Stop Sale: R 1250 GS, R 1250 GSA, R 1250 RT/RTP, S 1000 RR, S 1000 XR Caliper

Service Information Bulletin

34 02 20

ADVANCED INFORMATION: RECALL CAMPAIGN 20V-XXX CHECKING BRAKE CALIPERS

Example of Dot matrix code:

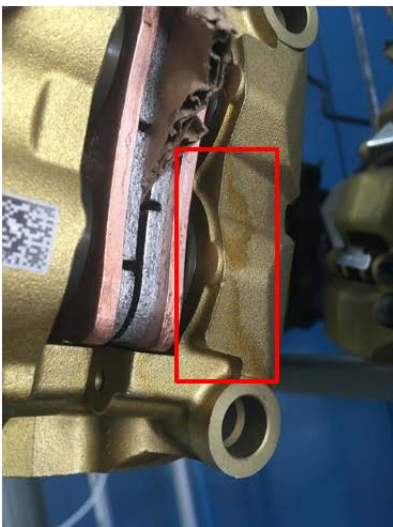
Please include a clear picture of code and serial number in the TSARA case.
